AMAN Hotel & Residences

Historic Preservation Board, September 16, 2025

HPB25-0662

Residences Elevation Modification – Vertical Lattice Removal

Proposed - Ground Level Site Plan

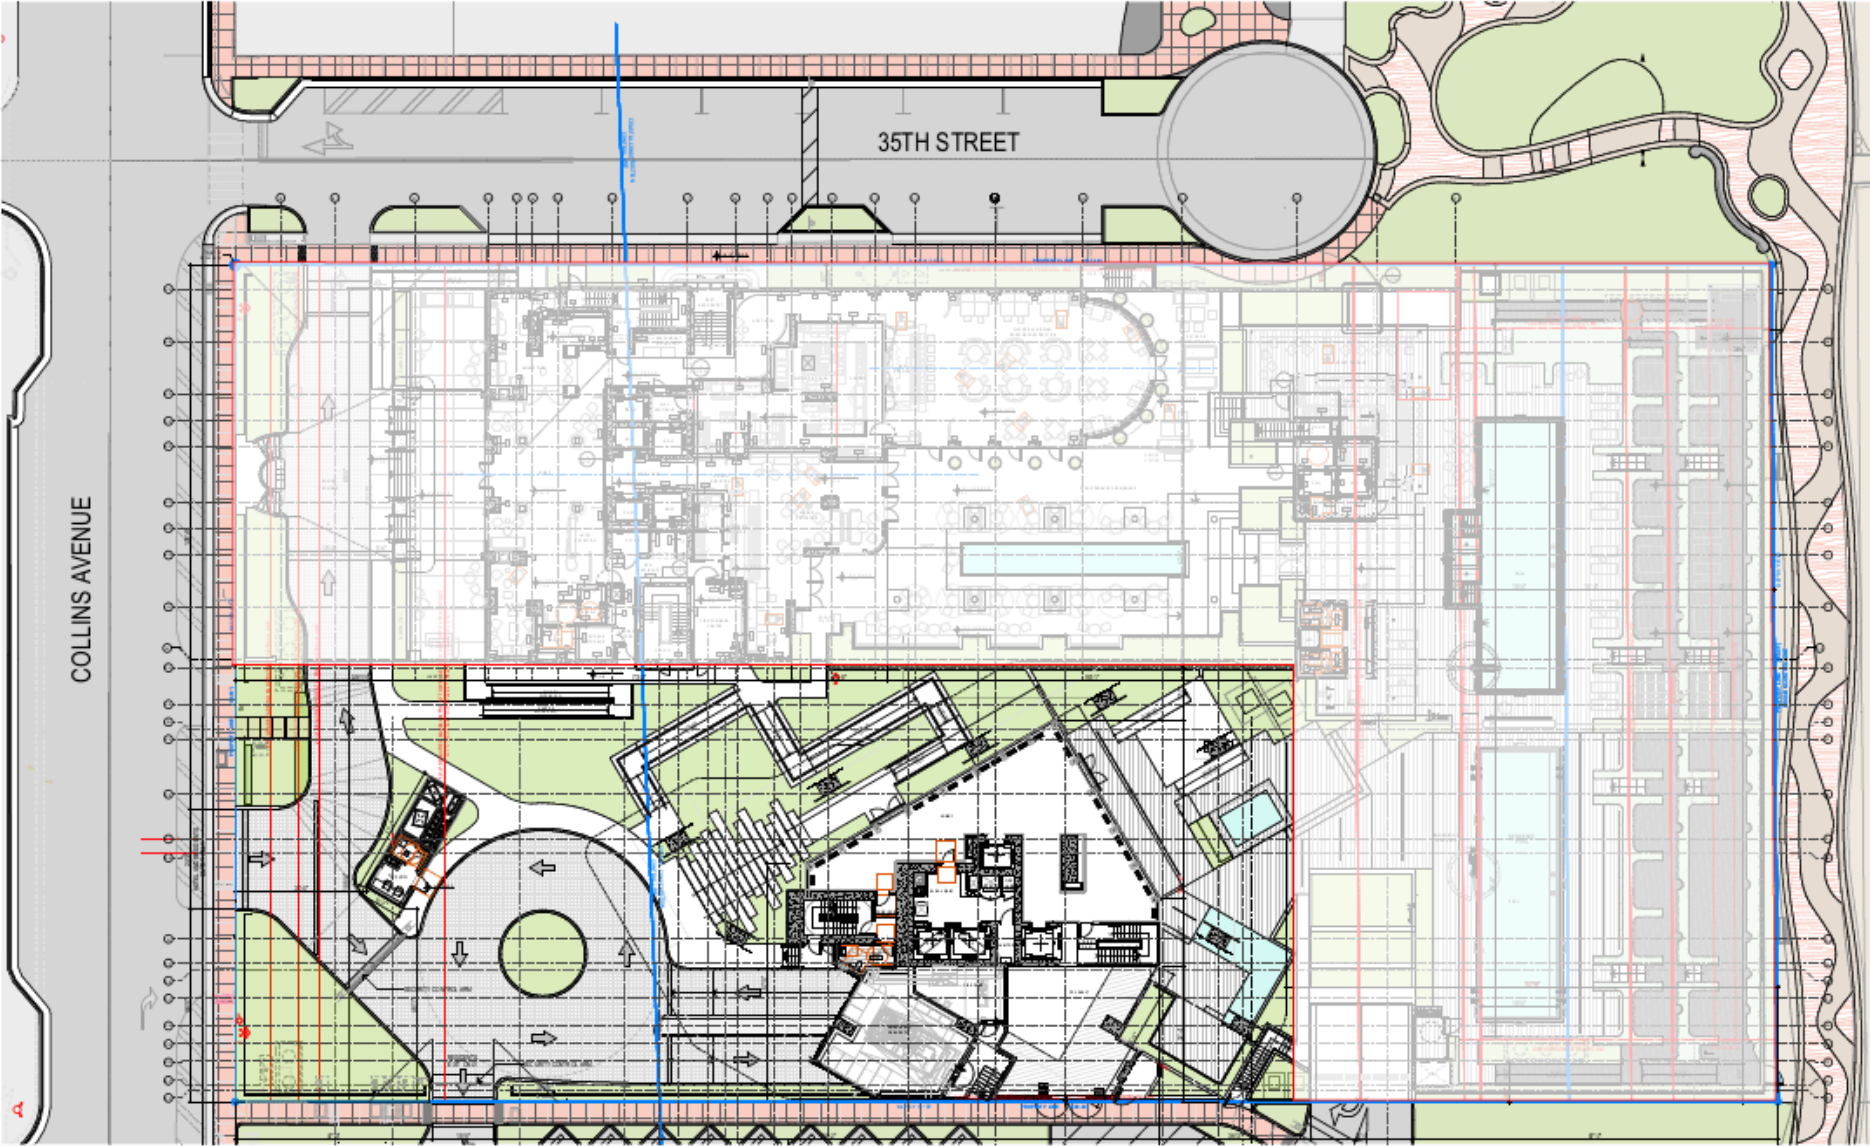
Remove Curbcut Remove Guardhouse

Guardhouse Single Structure

- Improved Pedestrian Experience
- Increased Openness at Restored Versailles
- Added Landscape at Collins Avenue

1. Approved Design Fails to Meet Structural Integrity Standards

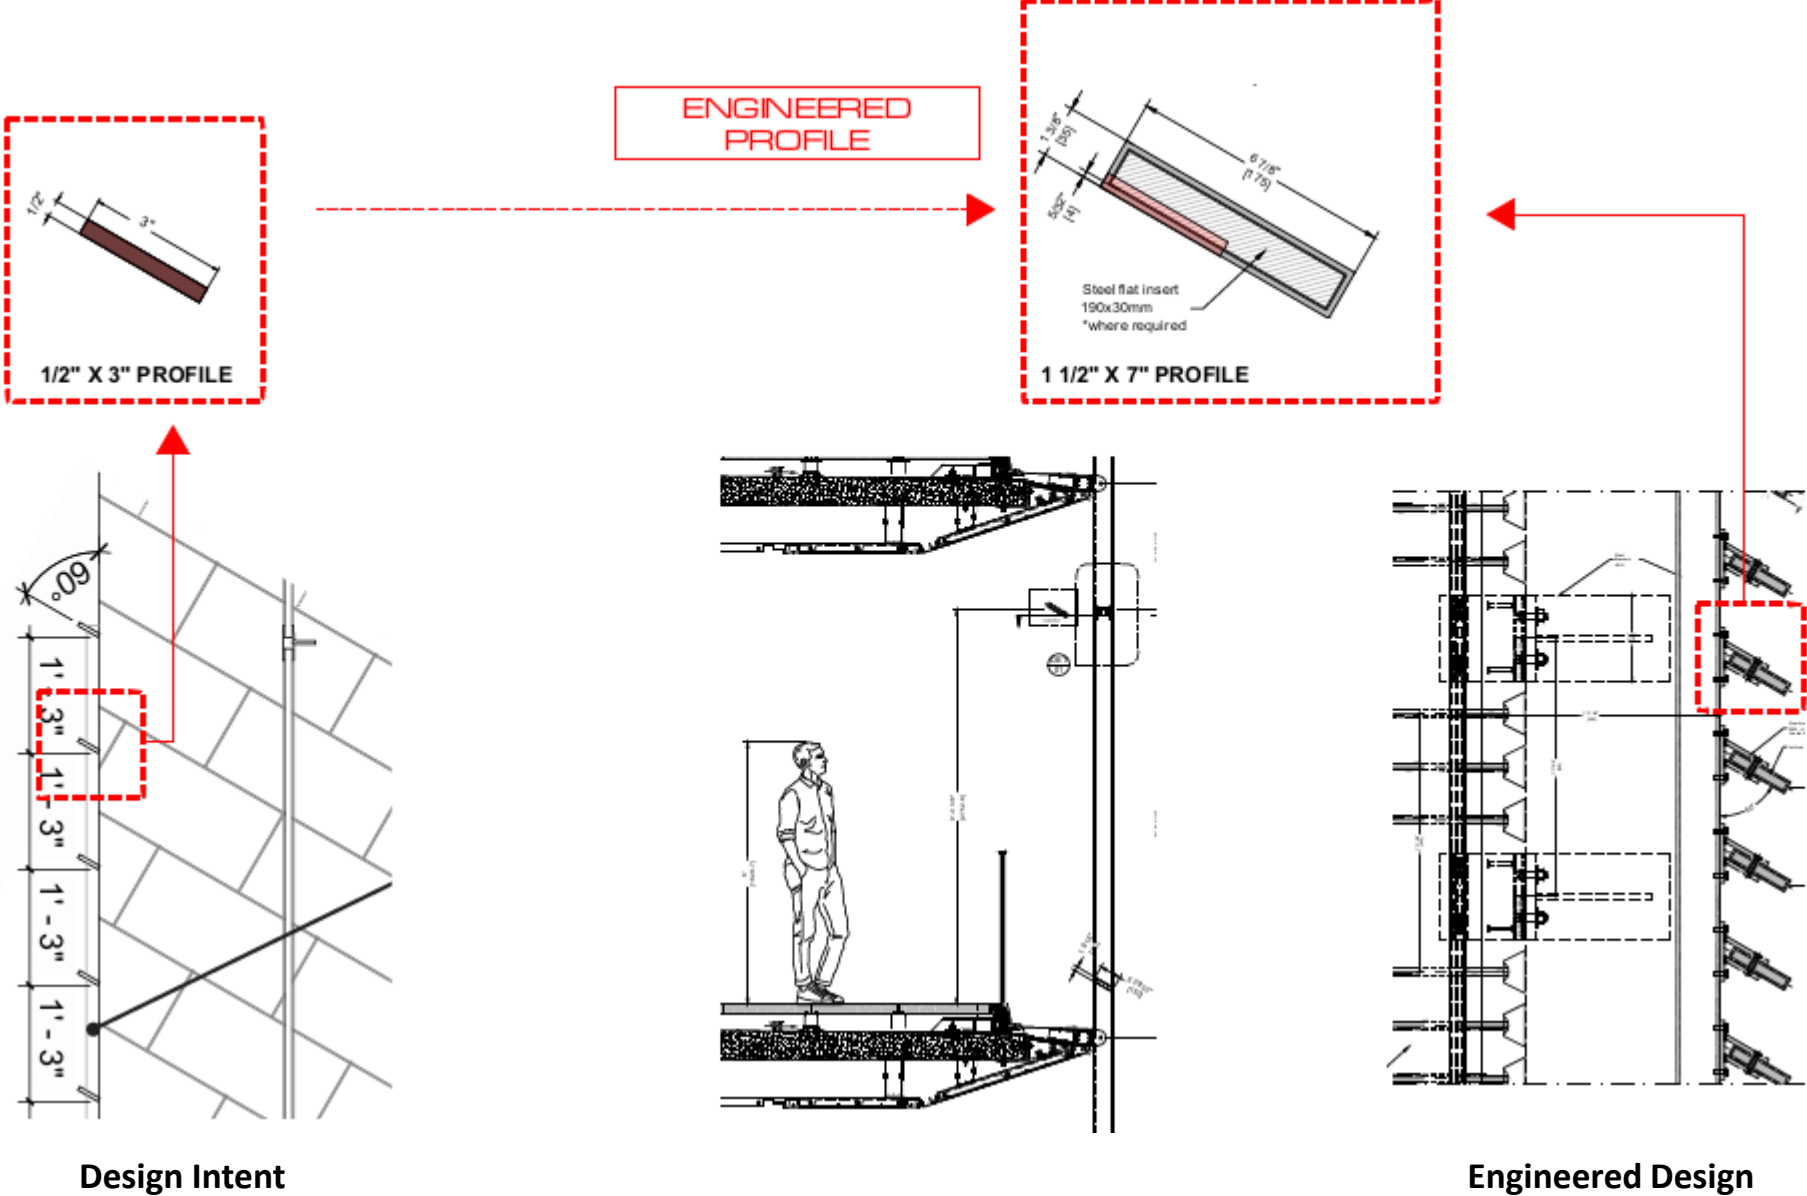
"The initial conceptualization featured thinner, more numerous lattice profiles intended to complement the building's aesthetic. However, engineering analyses revealed that these profiles, constructed from aluminum, presented significant structural challenges. **The slender design threatened to bend or even break under environmental stresses such as wind loads.** This deformation risk was heightened by the proximity of the lattice to the facade glass, posing potential contact and damage — scenarios unacceptable by structural integrity standards. **Additionally, compensatory design adjustments necessitated the profiles' thickening, deviating from the architectural intent and introducing further complications.**"

2. Operational & Maintenance Impediments

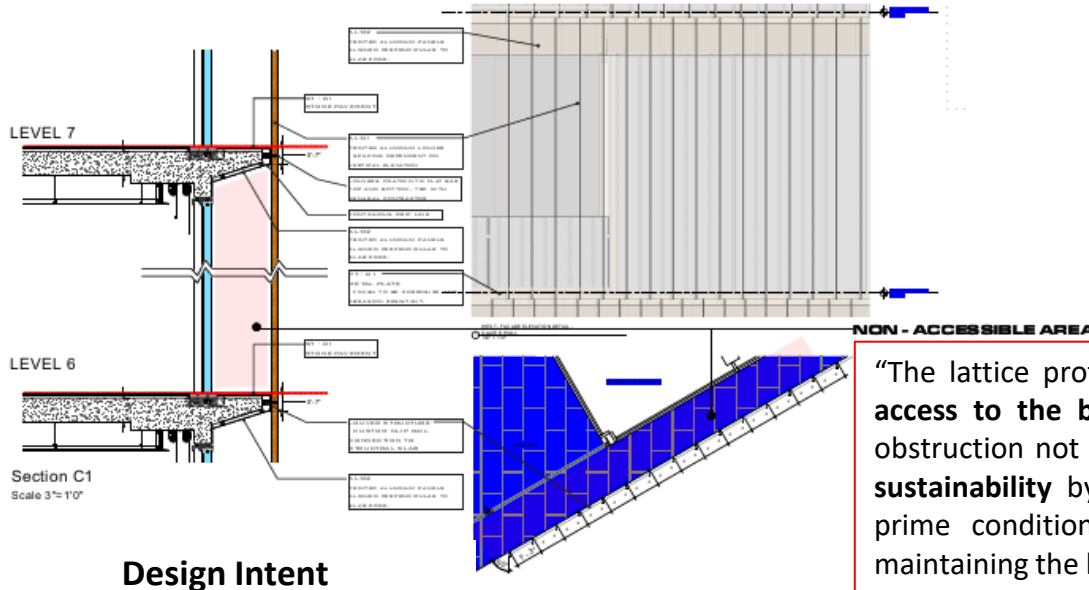
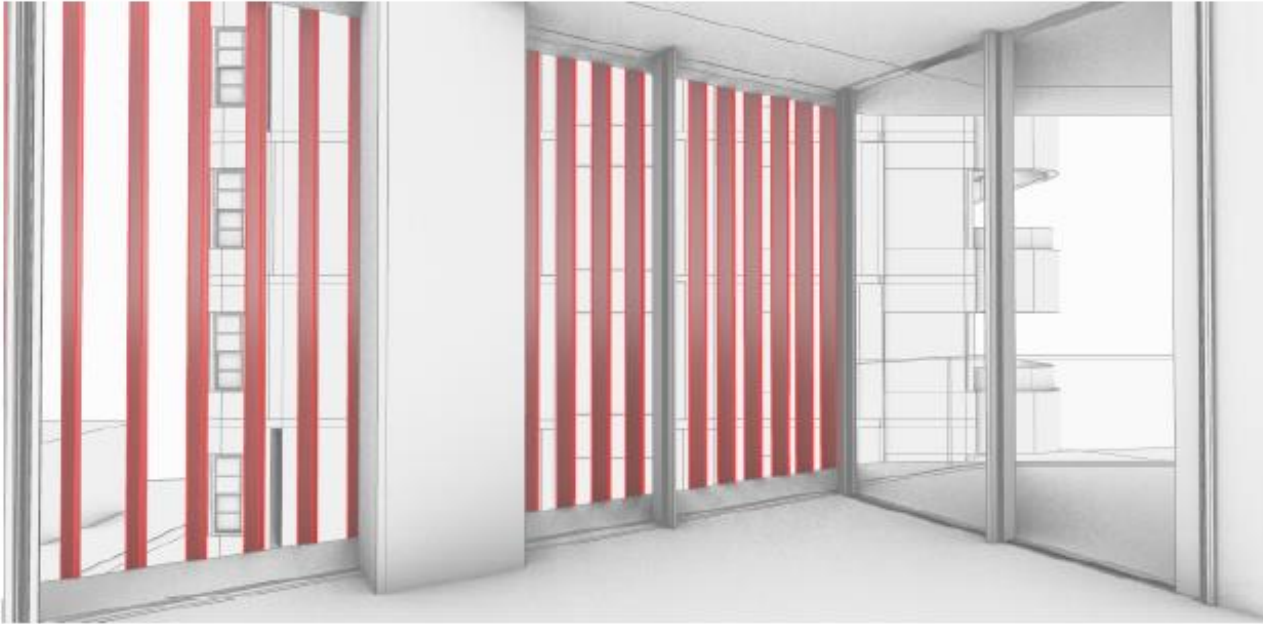
“The lattice profiles, in their original and modified forms, **severely obstructed access to the building's glazing for routine cleaning and maintenance.** This obstruction not only raises operational costs but also **diminishes the building's sustainability** by increasing the difficulty of maintaining the glass surfaces in prime condition. The lattice thus emerges as a prohibitive factor against maintaining the building's aesthetic and functional longevity....”

Interior View Study

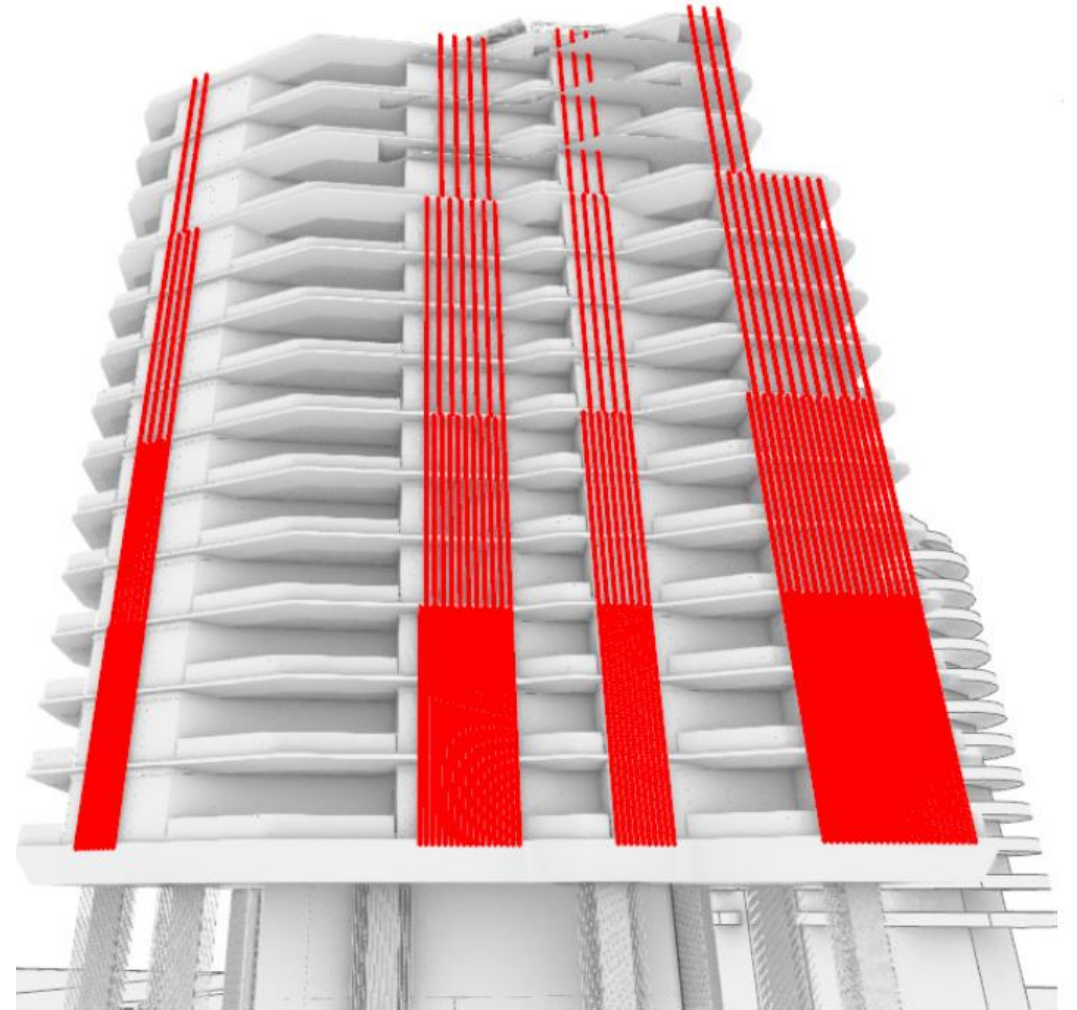
“In addition, the increased dimension of the lattice (to meet wind load requirements), substantially increases **obstruction of residents' views**, and **fails to meet the original design intent.**” - Lindner Engineering Report

Current Approval vs. Proposed – West View

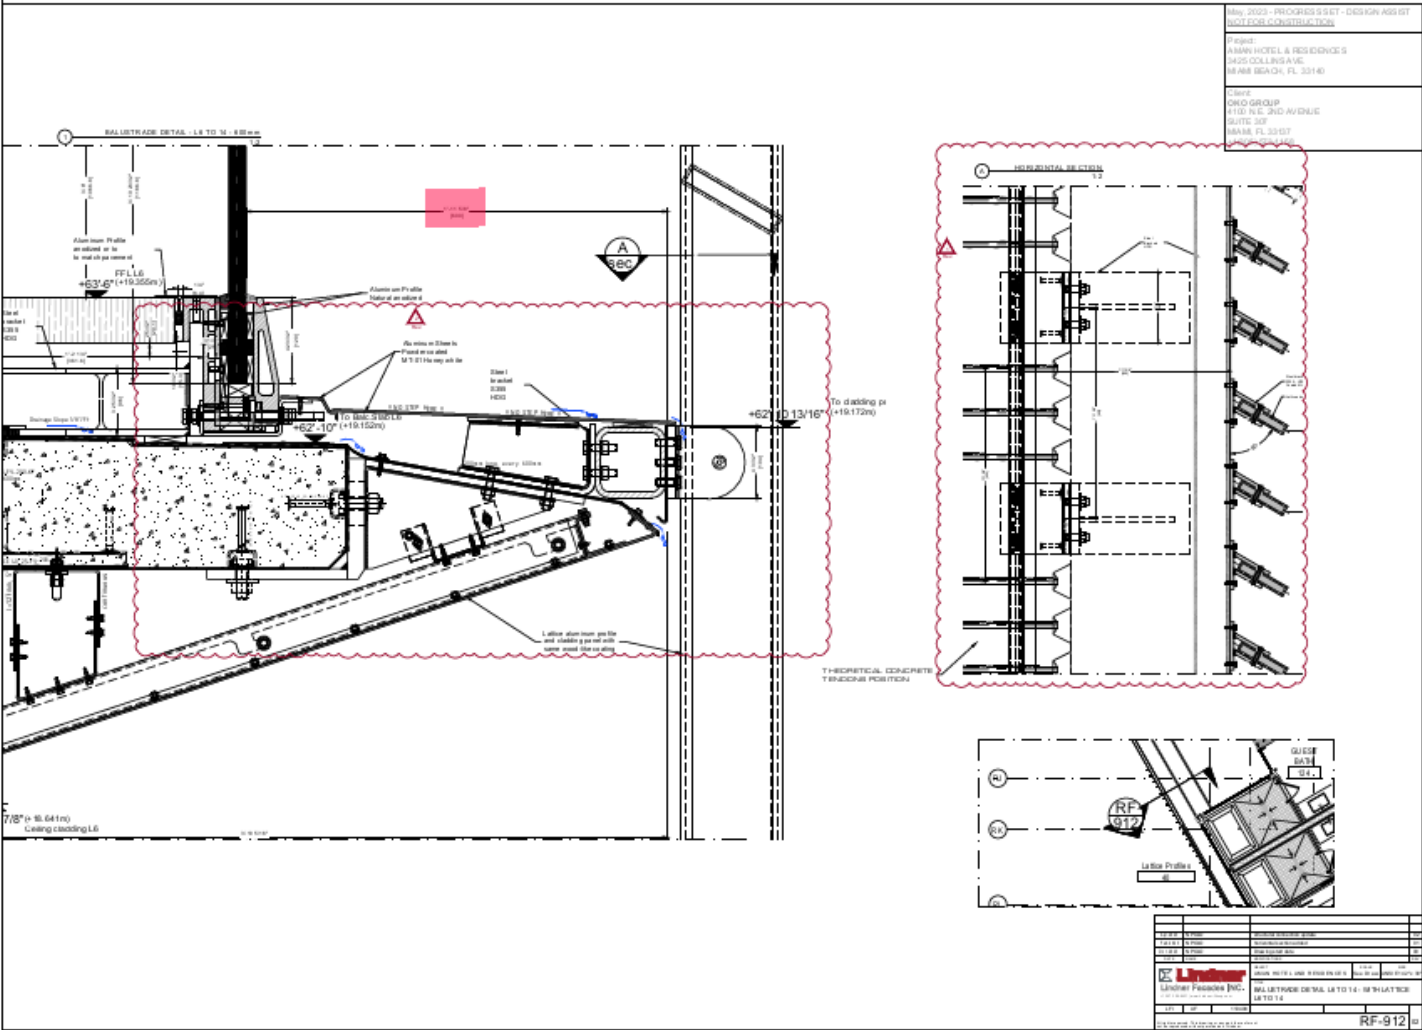
PROPOSAL TO REMOVE LATTICE

Wind Load Issues with Current Approved Design

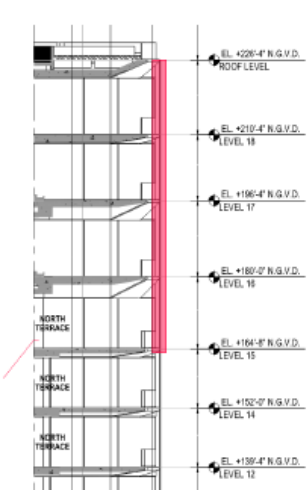
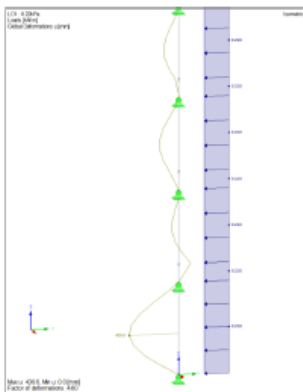
Deformation of the original lattice profile

$$f_{x,cont,1} := 436.6 \text{ mm} \quad \sim 17"$$

$$f_{x,cont,long,1} := 886.1 \text{ mm} \quad \sim 35"$$

looking at stress levels, this section is largely over-stressed in the upper (longer span) part utilization ratios are up to 248%

in the typical (shorter span) part utilization ratios are 124%, while they raise up to 137% in the first span.
